To: El Paso County Engineering Division
From: Mike Bramlett, PE
Date: November 25, 2020
Subject: Sand Creek Center Tributary Channel Improvements

# **SOLACE APARTMENTS - SAND CREEK CENTER TRIBUTARY**

**CHANNEL IMPROVEMENTS**

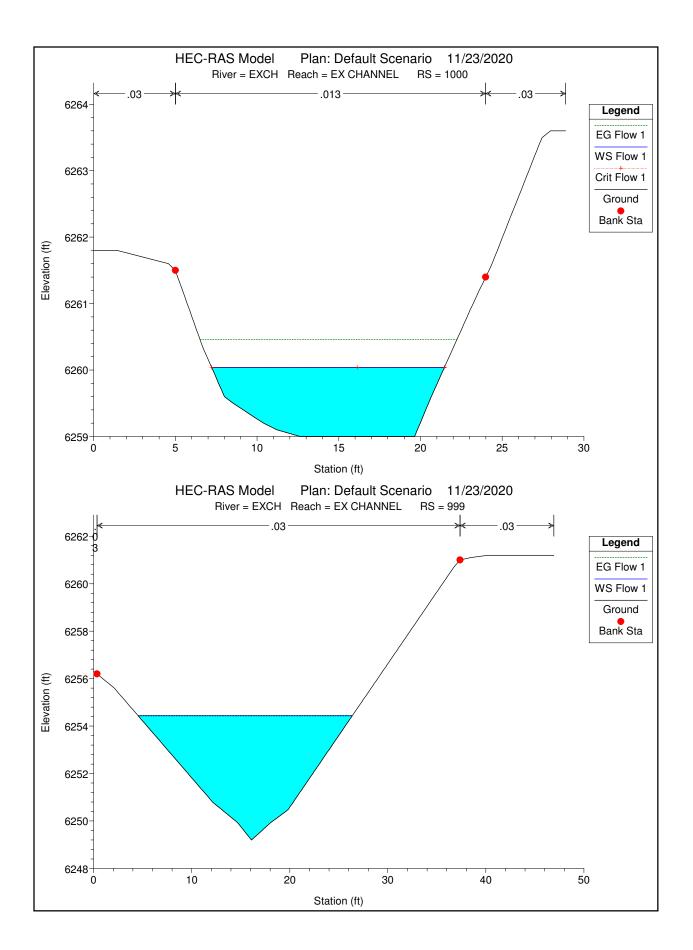
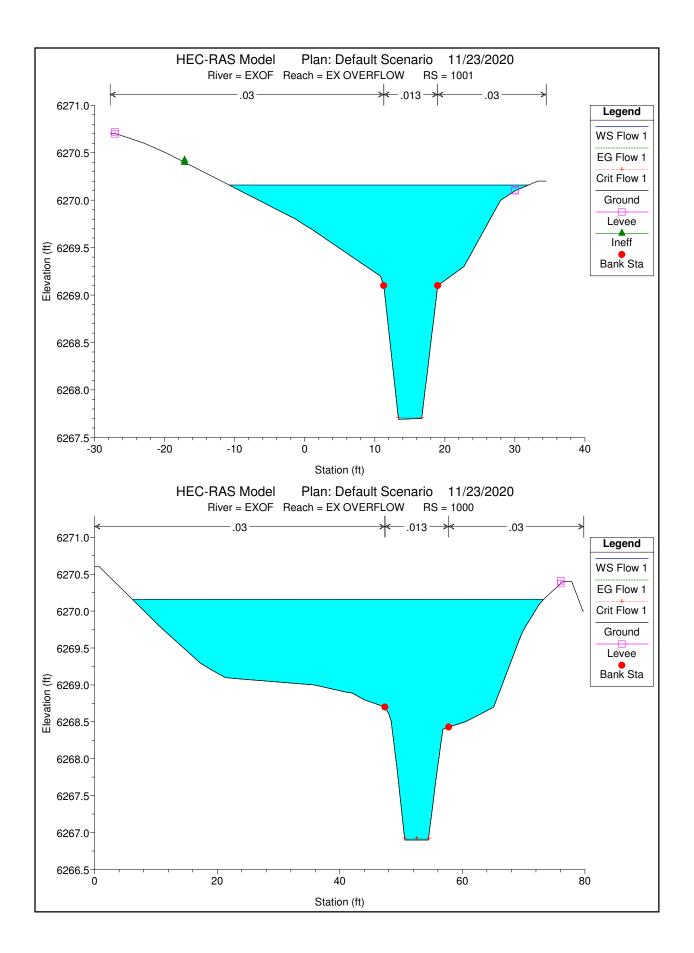
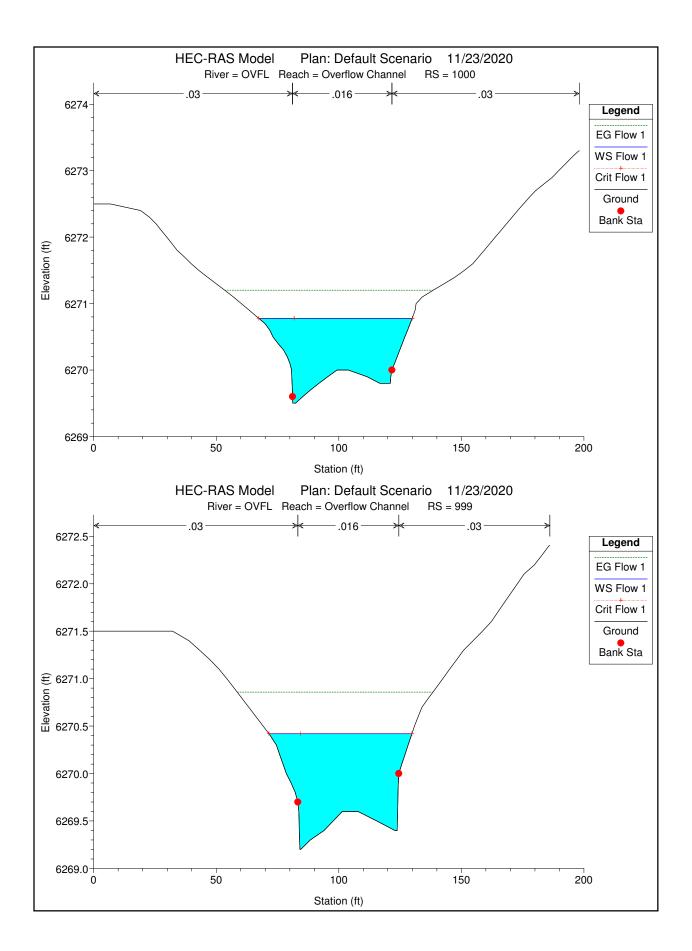
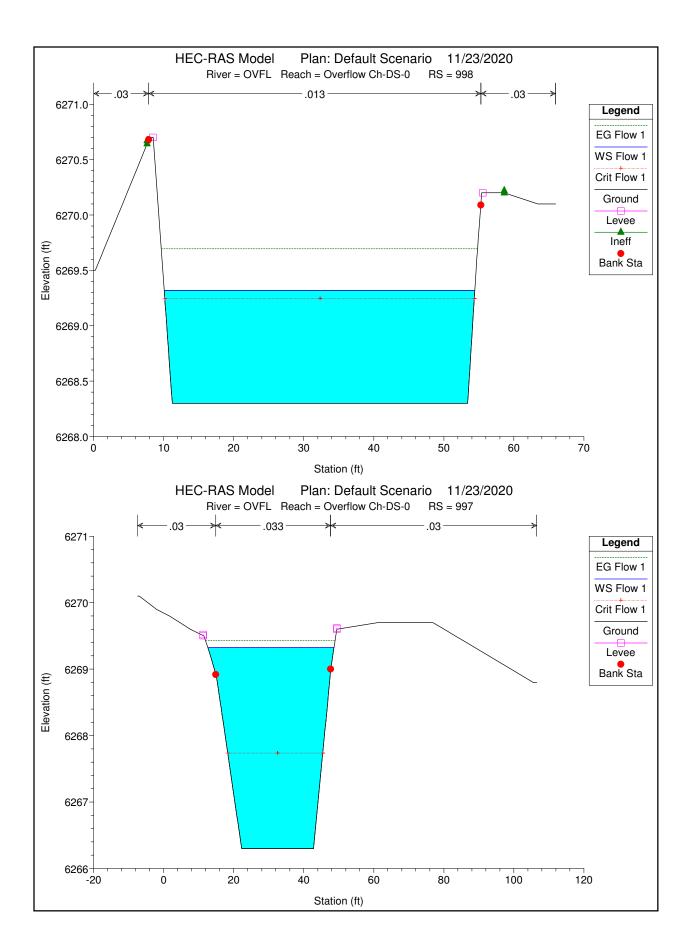
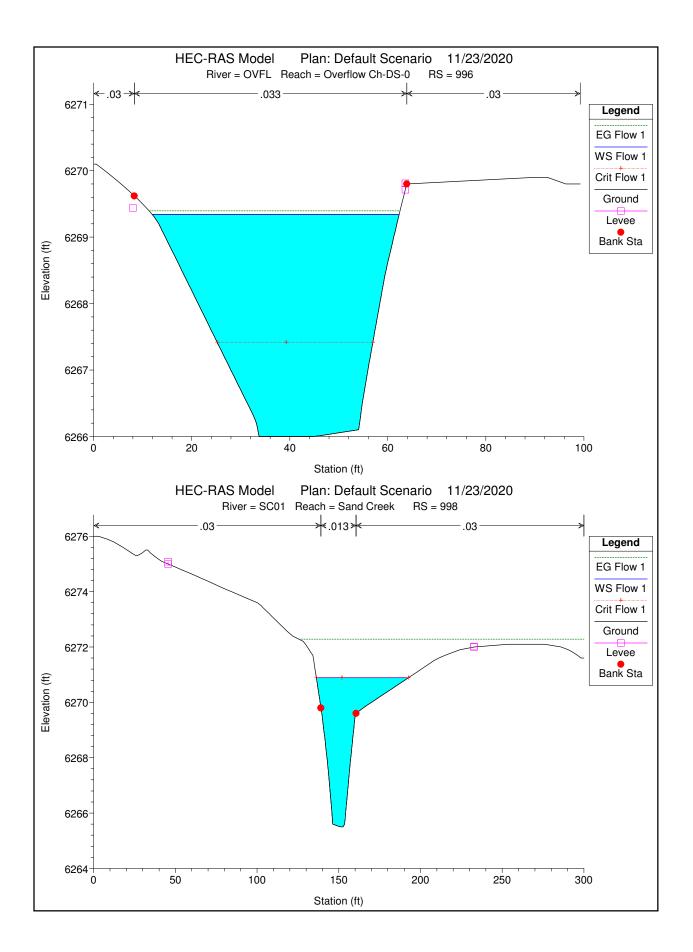
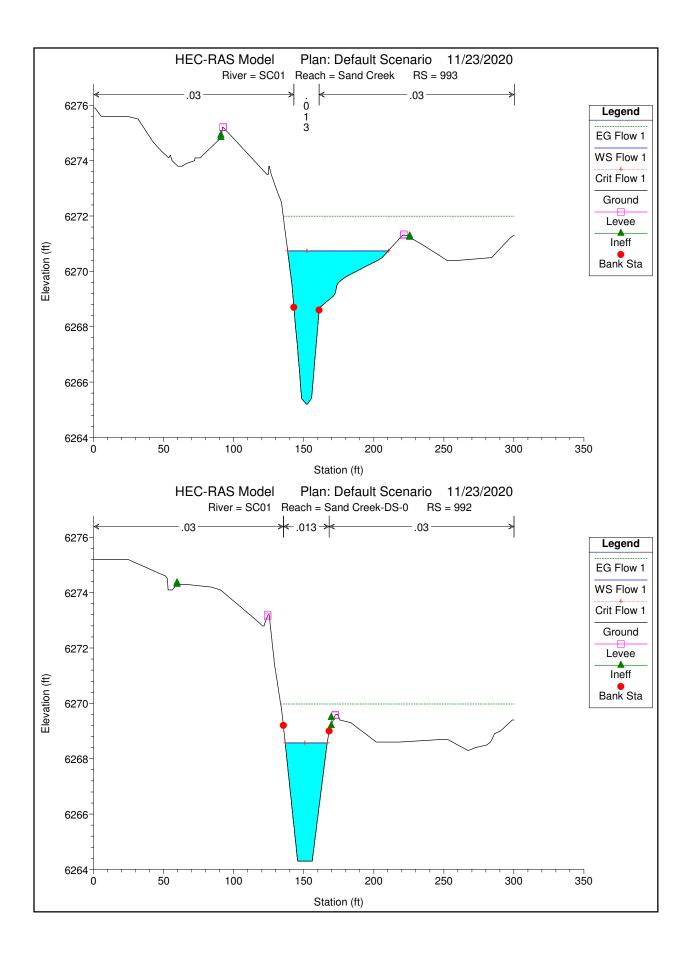
Provide the HECRAS Profile.

Please provide input/output data. Additionally we request that an electronic copy of the HEC modeling be provided. The electronic file may be sent via email.
